R
99V.069

RE: Lower Ball Joint Recall Campaign information.

BULLETIN NO.
99-023

Safety Recall: Lower Ball Joints

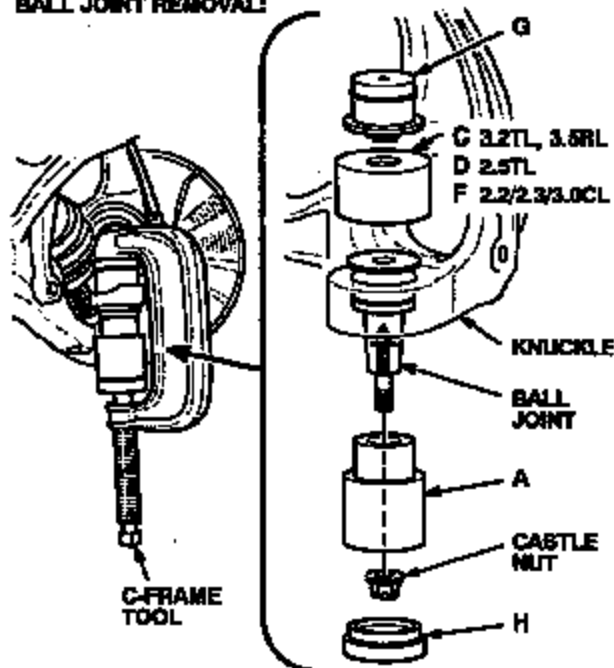
To avoid damaging base remover adapters C and F, be sure the tool is squarely seated on the lower arm and not hanging up on the ball joint.

Required Special Tool 07GAF-SD40310, Ball Joint Remover Base, can be used as a substitute for adapter C.

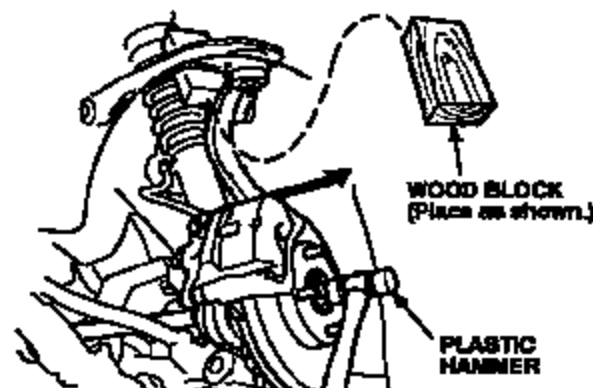
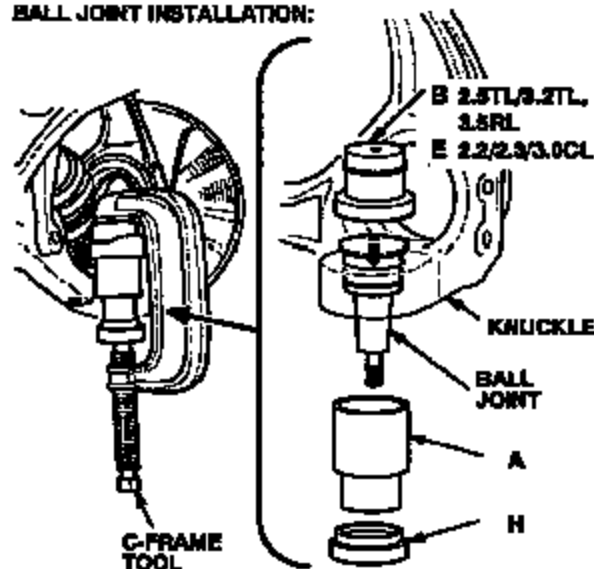
The Service Bulletin (S/B) for the Lower Ball Joint Recall (99-023) is incorrect. Steps 11 & 12 must be done before step 5. If 11 & 12 are not done before step 5, the wires for the ABS Sensor will carry the weight of the suspension. Consequently, the ABS Sensor will fail. We are faxing you a copy of the revised S/B today. To make it easy for you to distinguish the updated version that is being faxed we have eliminated the colored header (ACURA Service Bulletin) and hand-written a change of date (from May 13, 1999, to May 21, 1999). We will reprint and mail S/B 99-023 soon.

11. Remove the axle from the front wheel hub.

12. Lift the knuckle, then place a block of wood (approximately 2-3/4" x 1-1/2" x 5") between the upper control arm and the damper assembly.
13. Install the special tools on the ball joint and the knuckle.
